**SUBJECT:** **Safety Recall 16S41 – Supplement #2**  
 Certain 2010-2012 Model Year Escape and 2010-2011 Model Year Mariner Vehicles  
 with a 3.0L Engine  
 Fuel Delivery Module Flange Replacement

**REF :** Safety Recall 16S41  
 Dated: August 29, 2017

Safety Recall 16S41 – Supplement #1  
 Dated: October 26, 2017

**New! REASON FOR THIS SUPPLEMENT**

**FIGURE 9**

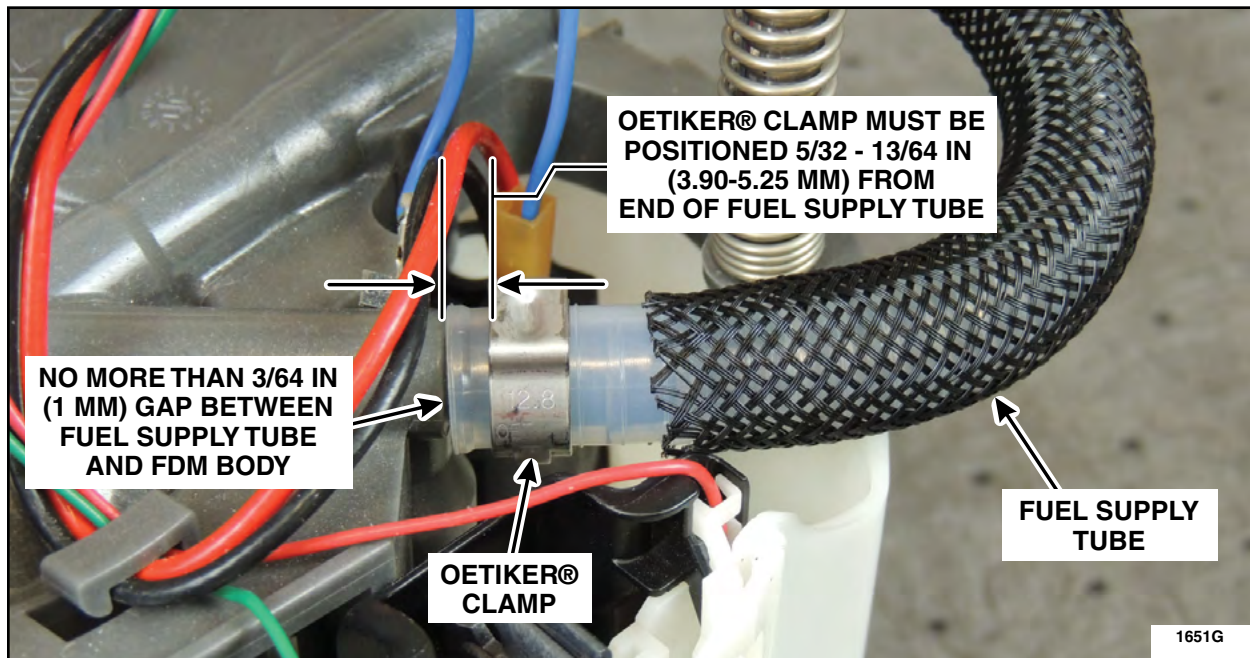
**NOTE:** *In the event an Oetiker® clamp is damaged or improperly clamped during installation, the Oetiker® clamp is available to order separate from the Fuel Delivery Module Flange Kit. Refer to the dealer bulletin for parts ordering information.*

9. Connect the *new* fuel supply tube to the supply port and tighten the Oetiker® clamp using Oetiker® clamp pliers. See Figure 9.

**NOTE:** The Oetiker® clamp must be positioned properly and tightened using Oetiker® clamp pliers only. Do not use side-cutter pliers to tighten the Oetiker® clamp. If the fuel supply tube or clamp are not positioned properly or the clamp is tightened using anything other than Oetiker® clamp pliers, this may result in a long crank or hard start concern due to fuel pressure bleed down.
